REFERENCE	BT_2013_X98CUP_01_UK
DATE	2013 March 21st
SUBJECT	Brake fluid reservoir cap

CONCERNED : 2013 EURO CUP CLIO

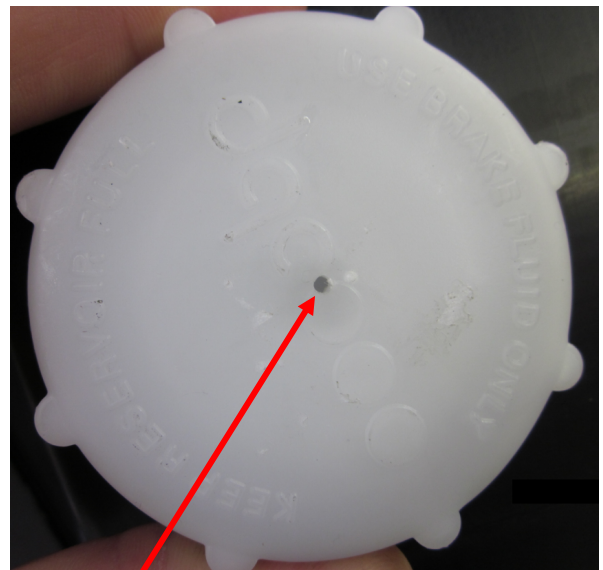
Renault Sport has found some brake fluid reservoir caps not drilled. The first cars delivered last week and this week may be concerned.

You must check the presence of a $\varnothing 2\text{mm}$ hole in the center of the cap.

If the hole is not present, you must drill it, following the instructions below:

1) Remove the cover from the cap (DO NOT DRILL THE COVER)

2) Drill a $\varnothing 2\text{mm}$ hole in the center of the cap
Make sure that no plastic chip stays in the cap before re fitting

The Presence of this hole is **mandatory** for evident safety reasons.
